2nd floor
 Ledger stud connection (2) 7 1/2" O.C.
 Per PPRBD
 Porch Cover handout
 Slope 1-18"
 Asphalt Shingles
 23 61 Springside Dr.
 2ft overhang of rafters
 2-2x8

Released for Permit
 02/23/2014 10:32 AM
 Pikes Peak REGIONAL Building Department
 bpeps
 CONSTRUCTION

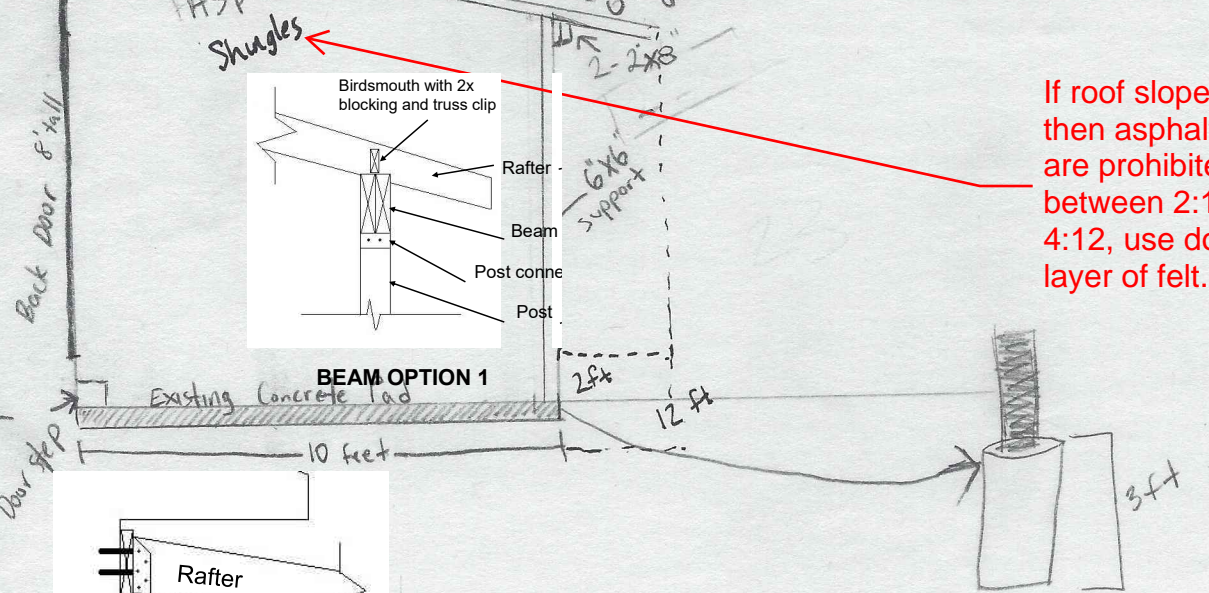
If roof slope <2:12, then asphalt shingles are prohibited. If between 2:12 and 4:12, use double layer of felt.
